**FHAD MODEL COMMENTS – SUBMITTAL 2  
MEETING MINUTES**

**Brantner Gulch MDP and FHAD  
Thursday, July 21, 2022  
11:00 am via Microsoft Teams**

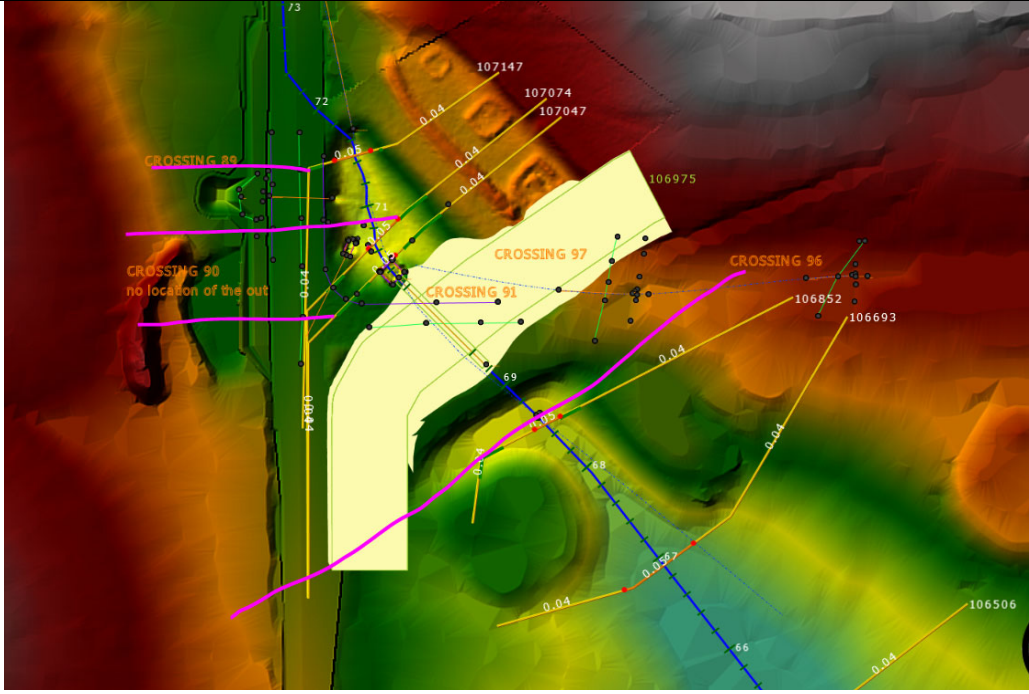
Agenda Number	Comment Page Number/ Object ID	Comment Source	Comment	Olsson Questions	Supporting Figures
2	92	General Comments - Word Doc	XS 63118, E 128th Avenue crossing structure, the conservative water surface elevation based on all flows flowing through the main culvert group is appropriate for the 500-year event. However, the 100-year event will have to be on a case-by-case basis. The existing inlet configuration including a spillway has been designed to consider the overtopping conditions. Do we have a copy of the hydraulic design report to help us understand the design hydraulics?	Comment 92: Plains Tributary – 100-year doesn't spill, 500-year WSE conservative and is controlled by structure 3 XS upstream.  Comment 95: Horizon Tributary – 100-year and 500-year WSE are conservative and controlled by structure up to drop structure.	
3	95	Model Related Comments - PDF	XS 82763, E 136 <sup>th</sup> Avenue, Horizon Tributary - Please see comment in the memo (comment 92 also applies here).	From the Report, in red: We would like to discuss the preferred path forward in the HEC-RAS model to see if reflecting a more realistic water surface elevation upstream of the crossing is desired. Potential solutions include: modify the road deck information to reflect the high ground in the LOB and add notes (drawback is it may appear road overtops for future users), hard code flow change immediately upstream and then downstream of the crossing (drawback is adding frequent flow changes, and dependent on outside calcs), add LS in this area and then hard code flow change (drawback is frequent flow changes).

Notes: JK, From a mapping standpoint, if the mapping is showing the flows going through the culvert we should show that. If the floodplain is on the trail, he isn't worried. As long as we are accurate in the mapping, and aren't showing structures in the floodplain, the backwater into the area on the left near the 7 Eleven on the west side of the above screenshot is a detention pond and he isn't worried about this.  
 HTH: Prefers a more simplified, conservative approach. Leave as is, since it is conservative and there is not anything concerning in terms of where the floodplain is impacting.

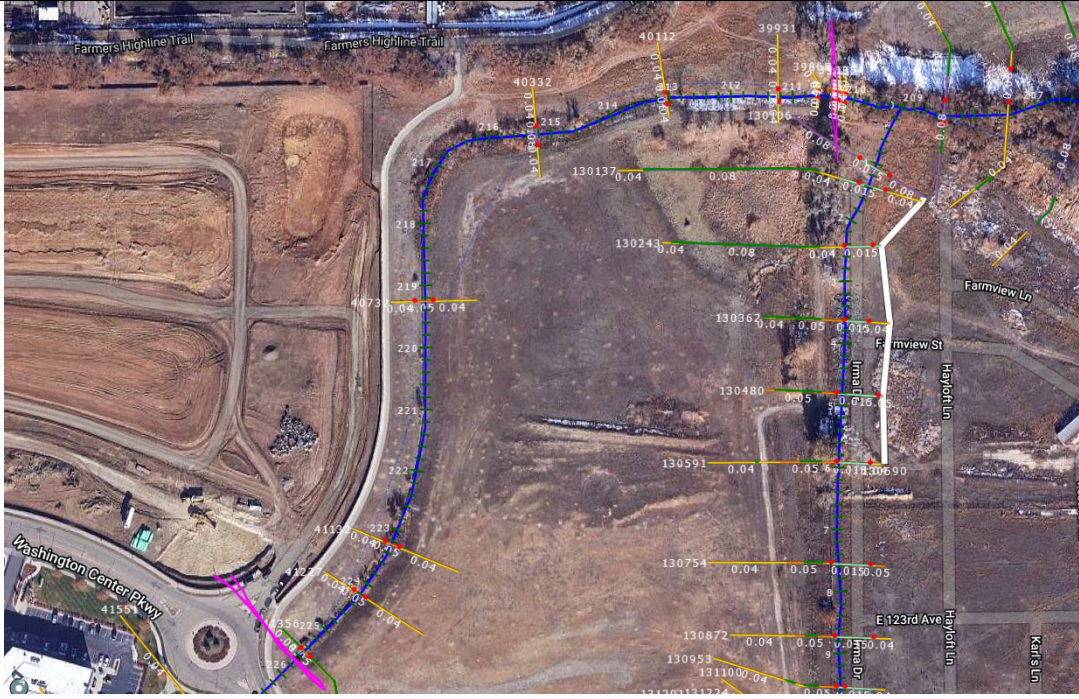
Agenda Number	Comment Page Number/ Object ID	Comment Source	Comment	Olsson Questions	Supporting Figures
6	PDF page 28	Model Related Comments - PDF	Did the FlowMaster analysis consider the area downstream of the existing detention to Colorado Blvd? If not, a few cross-sections at several critical locations might be necessary to understand the 500-year floodplain extents.	No, the flowmaster is from a cross section that cuts across 123rd Dr, then it is assumed that the flows go into the detention pond, then into the storm system. For reference, 100-year spill is 15 cfs and 500-year spill is 220 cfs. Does the full spill need to be modeled until it returns to Brantner Gulch? What additional analysis needs to be performed in this area?	
<p><b>Notes: This is on-site detention pond. Assume that the pond is full for the 500-year event so that we can understand how flows spread out downstream. Cut two or three cross sections in FlowMaster downstream of the pond where flows spill. If it is contained in the street, then we will not need an actual split within the model and it can be mapped based on the normal depth calculations. Check to see if the 2020 LiDAR needs to be referenced in this area for improved resolution.</b></p>

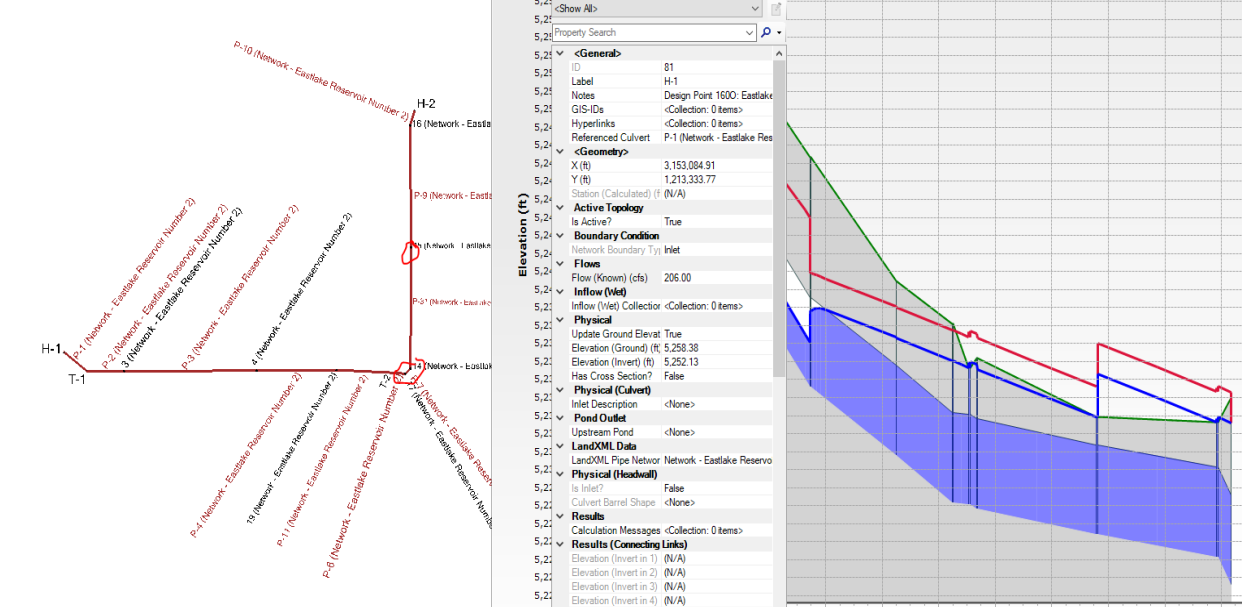
Agenda Number	Comment Page Number/ Object ID	Comment Source	Comment	Olsson Questions	Supporting Figures
10	16/91	MHFD Comment Shapefile	Please consider an additional cross section at the weir for modeling overflow. Use set water surface elevations.	Discuss modeling the notch. No separated flows are currently calculated.	
11	17/91	MHFD Comment Shapefile	Please consider an additional cross section at the top of the trail crossing for modeling overflow condition and flow change location.	Discuss modeling the notch. No separated flows are currently calculated.

**Notes: Current approach is enough. Sometimes the spillway distance between upstream and downstream cross section is so long and if structures are close to the floodplain, more detail is needed. Since that is not the case here, the simplified approach is OK.**

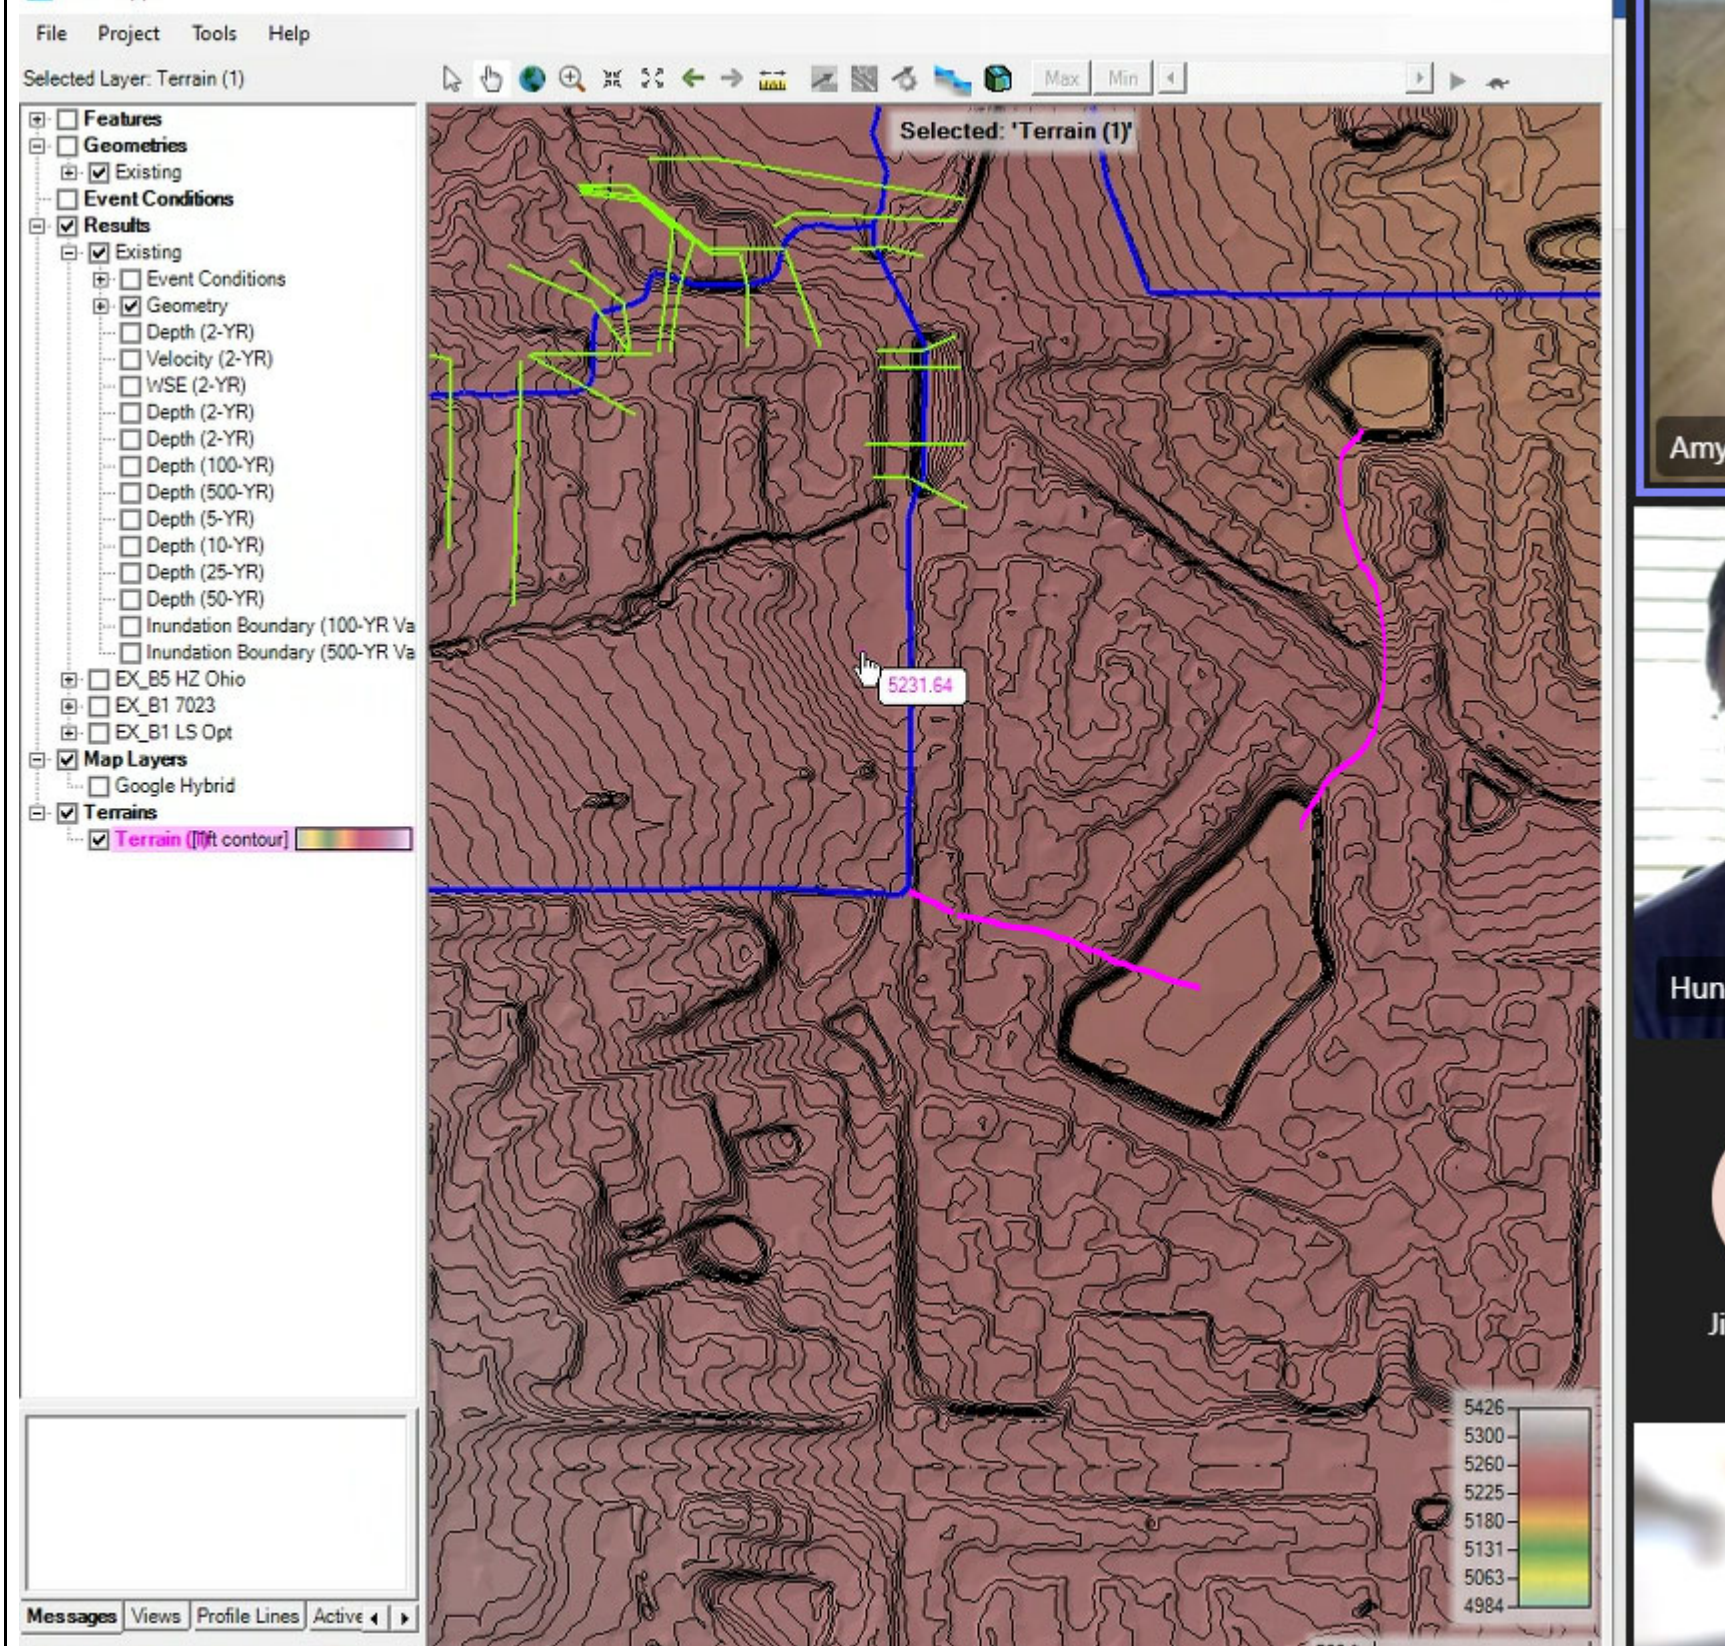
Agenda Number	Comment Page Number/ Object ID	Comment Source	Comment	Olsson Questions	Supporting Figures
12	12	MHFD Review Shapefile	Okay. Let's discuss adding the culvert back to the hydraulic model to provide detail for flood profiles since the overtopping condition was modeled with a separated reach./ Let's discuss the modeling approach for overtopping flow condition at a crossing structure that was not directly modeled due to hydraulic complexity.	Discuss modeling approach at Detention Pond H306.

Notes: Add the culvert back in since we have an offset spill reach. Move the flow change that reflects the detention pond outflows to the cross section immediately upstream of the crossing and keep the set water surface elevation at this location.

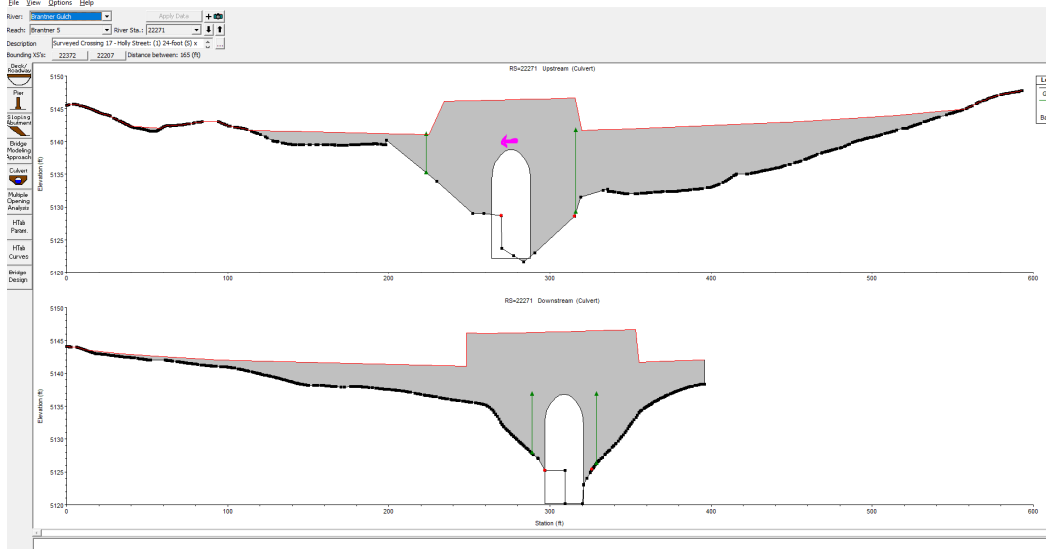
Agenda Number	Comment Page Number/ Object ID	Comment Source	Comment	Olsson Questions	Supporting Figures
13	15	MHFD Review Shapefile	XS 41356 replaced previous XSs. Invert elevation 5303.5 does not match the surveyed invert elevation 5303.61.	The flowline was interpolated between survey points. Since the cross section is downstream of the survey point, the interpolation resulted in a lower elevation. Need to confirm approach is acceptable.

Notes: Provide explanation in description. Jim noted the development is piping the channel in this reach and it is under construction. If updated information is received in time, it can be incorporated into the model, otherwise the model will show the pre-development conditions.

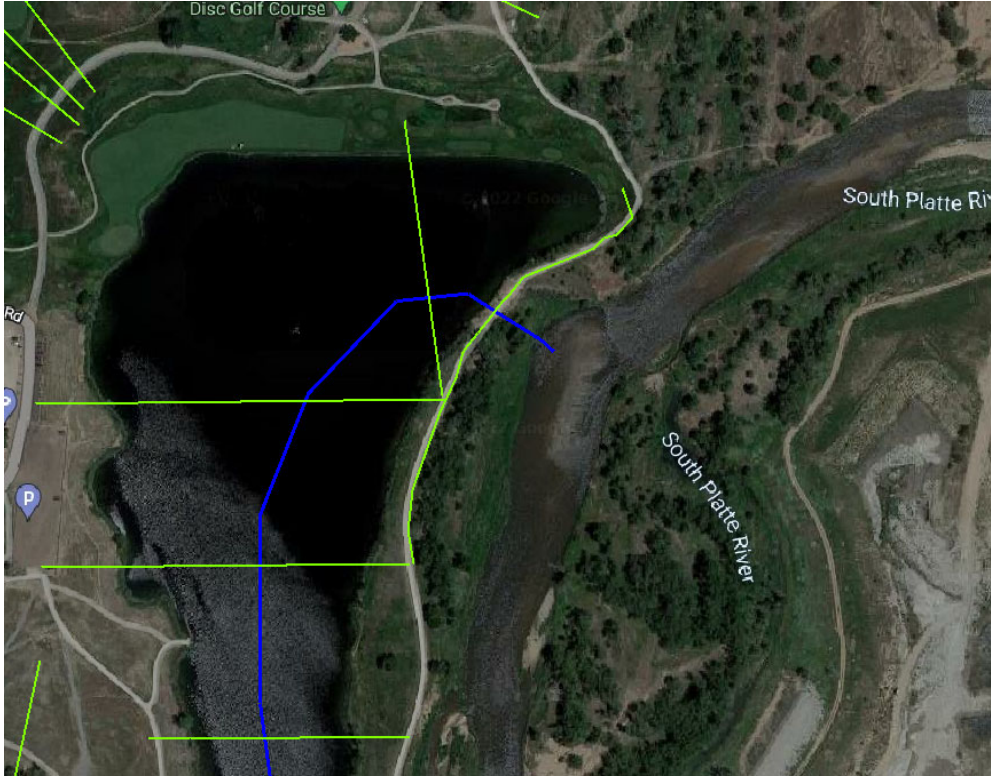
14	32	MHFD Review Shapefile	Okay with the response. Please look at the potential overflows bubble out of manhole and estimate if it warrants a 1D model for computing the flood risk or a normal depth calculation suffices.	At the bend in the pipe, the storm pipe has capacity for the 100-year flow, but will surcharge in the 500-year (difference of 33 cfs). Storm pipe has a capacity of 160 cfs before the HGL is above ground at the lower end. 100-year flows are 206 cfs (46 cfs difference) and 500-year flows are 239 cfs (79 cfs difference) in the pipe.	
----	----	-----------------------	--	---	---

Notes: Add a few cross sections to see if the 33 cfs is carried in the street in FlowMaster. Assume downstream pond is full, confirm it stays in the street based on the normal depth calculations and see if we need a split flow. Add two more additional cross sections north of the cursor. Use 2020 LiDAR to analyze this area in more detail.

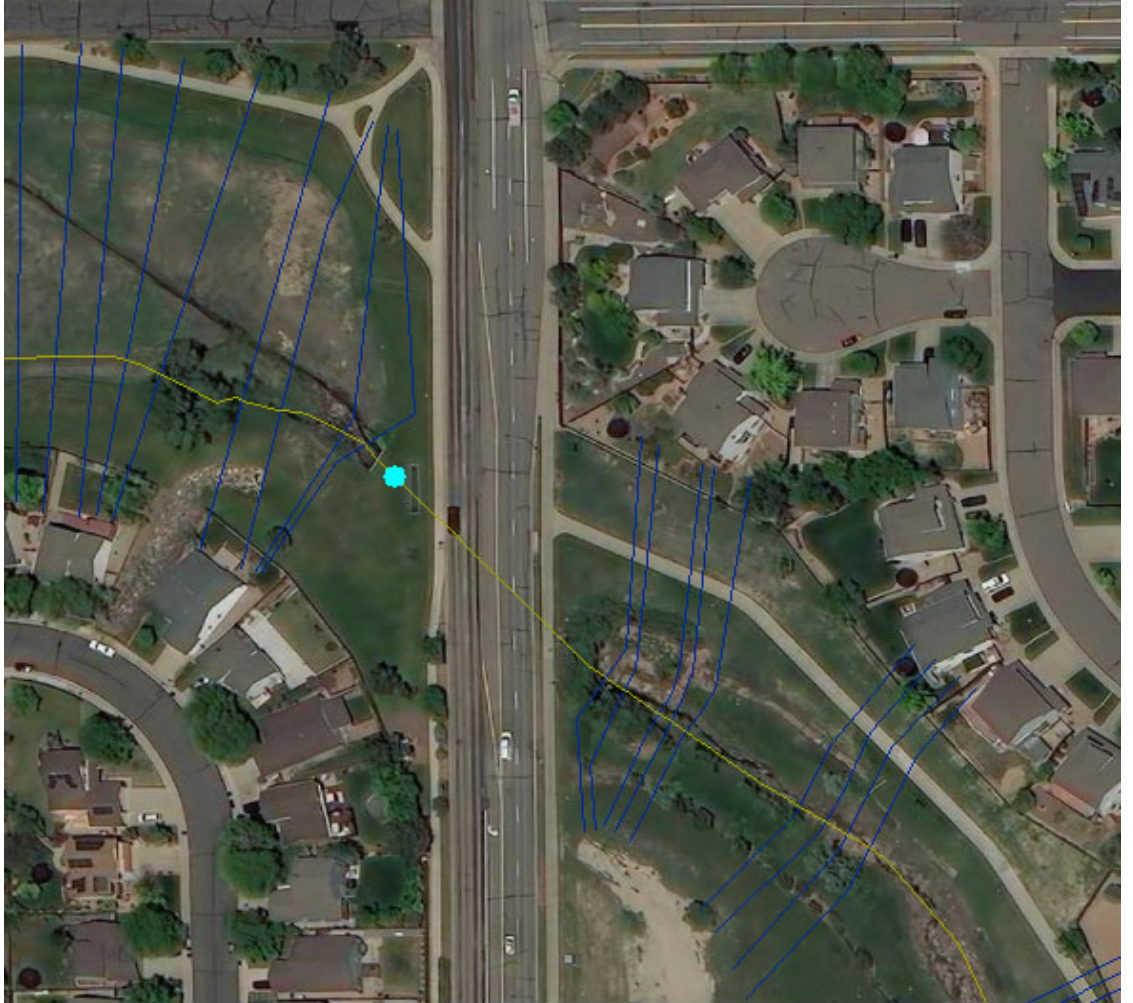
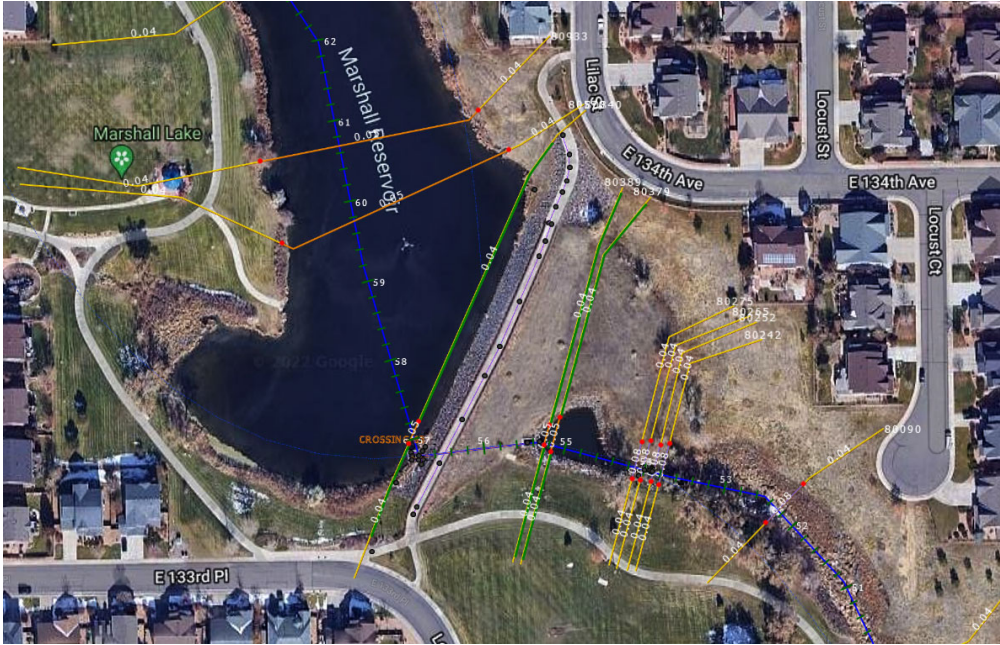
Agenda Number	Comment Page Number/ Object ID	Comment Source	Comment	Olsson Questions	Supporting Figures
15	44	MHFD Review Shapefile	Please confirm the updated invert elevation 5181.57 that does not match the surveyed invert elevation 5181.75 or provide a clarification.	The elevation of 5181.57 is an interpolated value between the invert of the culvert upstream and the crest of the drop structure downstream. There are notes in the description of the cross section saying this. Need to confirm approach is acceptable, same as comment 15.	n/a
<b>Notes: Approach is good, make sure the notes are in description.</b>					
16	54	MHFD Review Shapefile	It is correct to add pedestrian crossing information to the bounding cross-sections. The trail embankment, using depth blocked, should be added inside the conspan to reflect the true effective flow area.	Should we come up with a depth to block the bottom of the culvert that is equivalent to the reduction in area caused by the pedestrian trail embankment?

<b>Notes: Fill in the bottom based on the equivalent area for the conspan.</b>

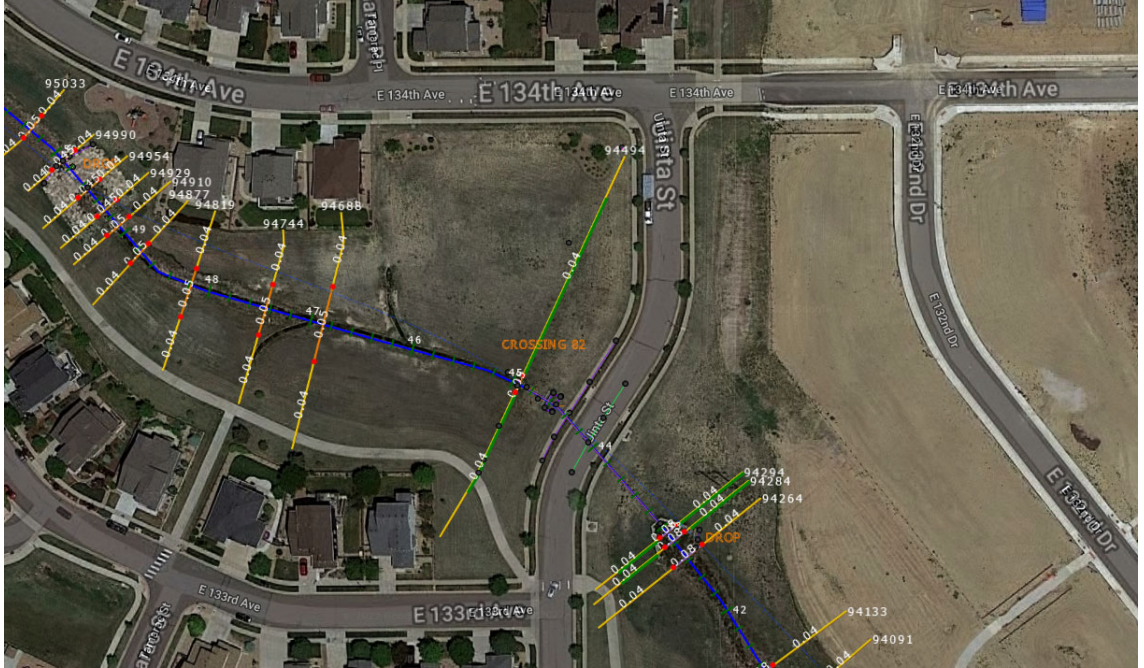
Agenda Number	Comment Page Number/ Object ID	Comment Source	Comment	Olsson Questions	Supporting Figures
17	76		<p>The lowest berm elevation was found to be approximate 5004 instead of 5008. Please update the elevation for blocked obstruction. Let's discuss using limited cross-sections and adjusting cutline alignment to facilitate the model setup.</p>	<p>Discuss modeling updates</p>

Notes: Don't need the 400 feet interval of the cross sections in this area. Want to represent the spill and add the backwater. Have one on the berm and remove some of the cross sections in the detention pond area.
